PN-EN 30-1-1+A2:2010/AC

Wprowadza
EN 30-1-1:2008+A2:2010/AC:2011, IDT

**Domowe urządzenia do gotowania i pieczenia na paliwo gazowe -- Część 1-1:
Bezpieczeństwo -- Postanowienia ogólne**

**Poprawka do Normy Europejskiej EN 30-1-1:2008+A2:2010/AC:2011 Domestic cooking appliances
burning gas - Part 1-1: Safety - General**
ma status Poprawki do Polskiej Normy

Figure 7

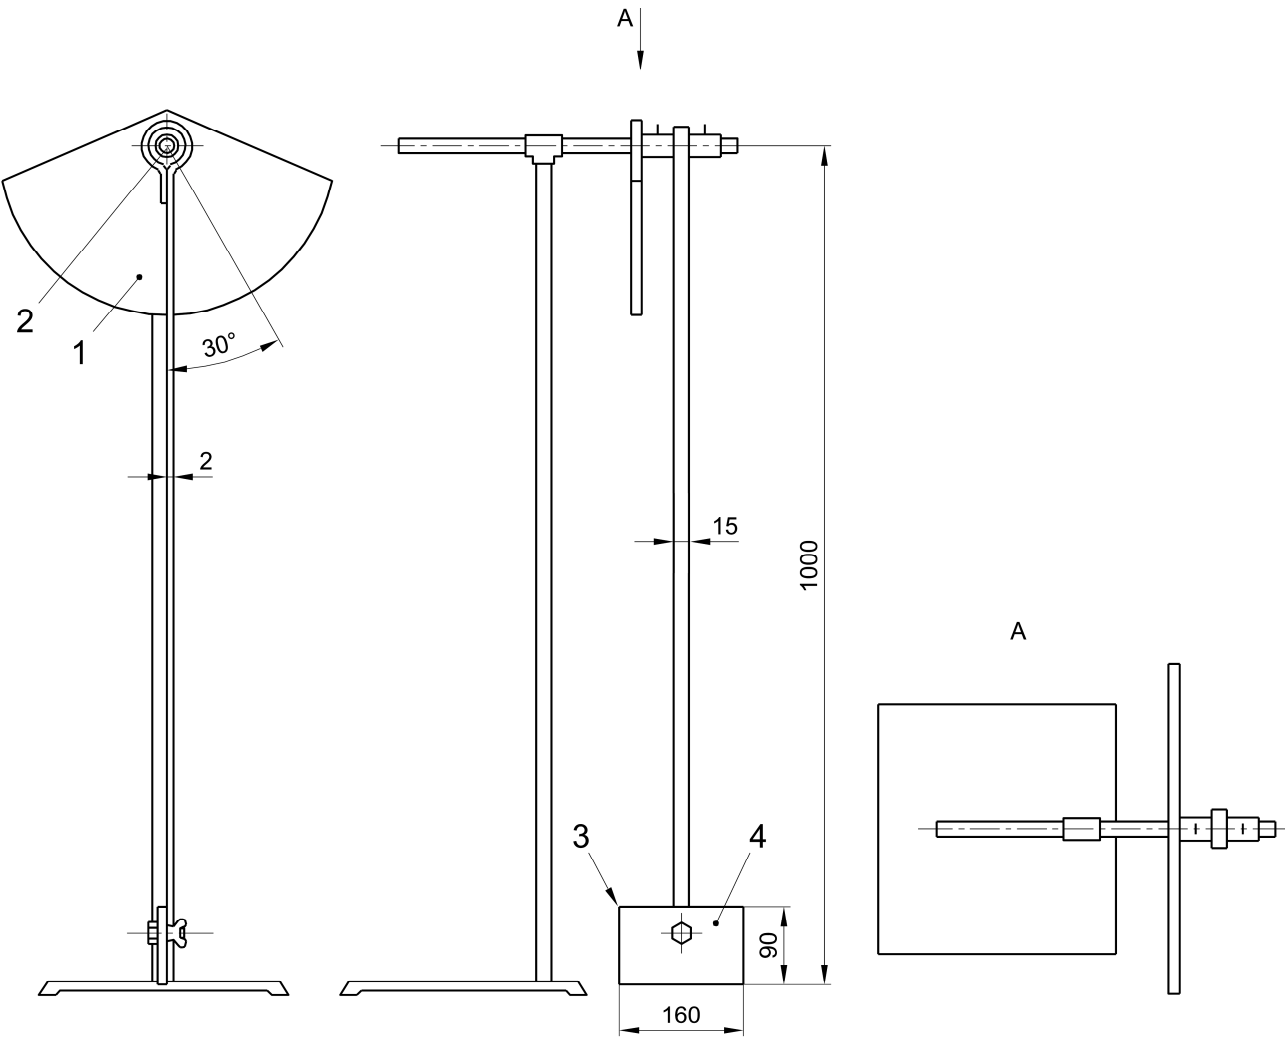
Replace the figure with the following: "
